## Contribution from BSTOR SA/NV to the consultation organized by Elia on the design note related to the evolution of the connection with flexible access framework at the federal level.

Figure 9 : Maximum allowed connection capacity per voltage level for source substations and remote substations

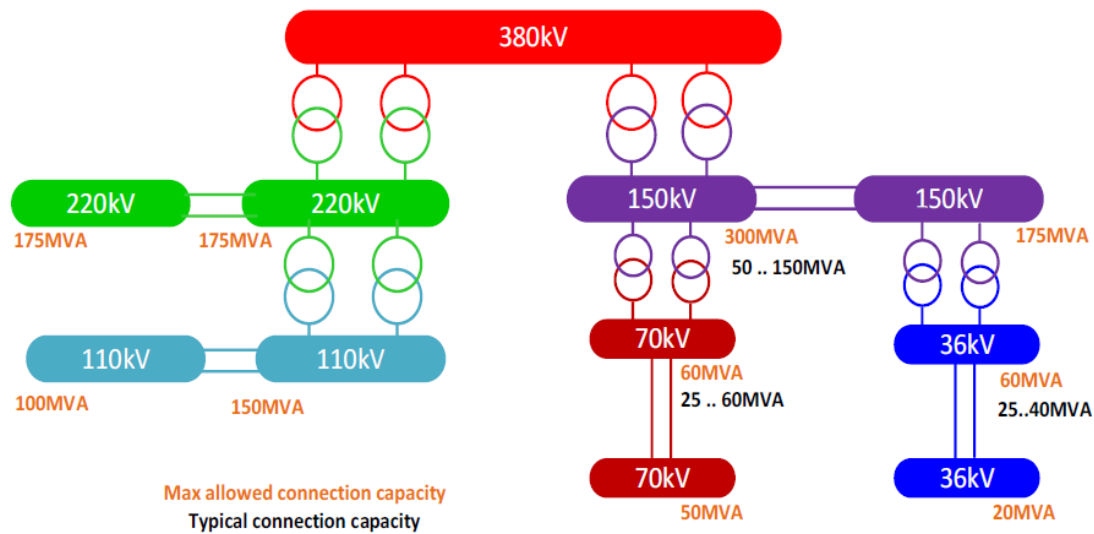
Aren't there typos in this graph?
